Car Stereo Service Bulletin

Model: CDX-900

No. 326

Subject: No Display/No Backlighting.

RESET BOARD

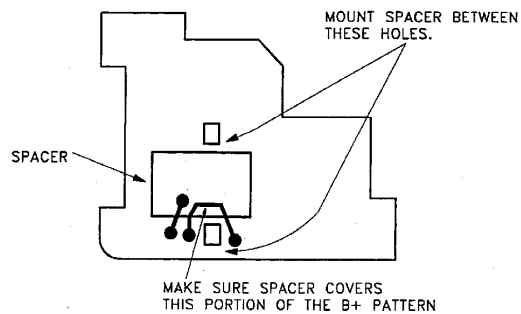
The unit does not have any display and/or backlighting.

2- Install a spacer on the B side of the Reset board as shown below. The spacer prevents the B+ pattern from shorting to the metal chassis.

REF	DESCRIPTION	PART NUMBER
-	SPACER	3-892-163-11
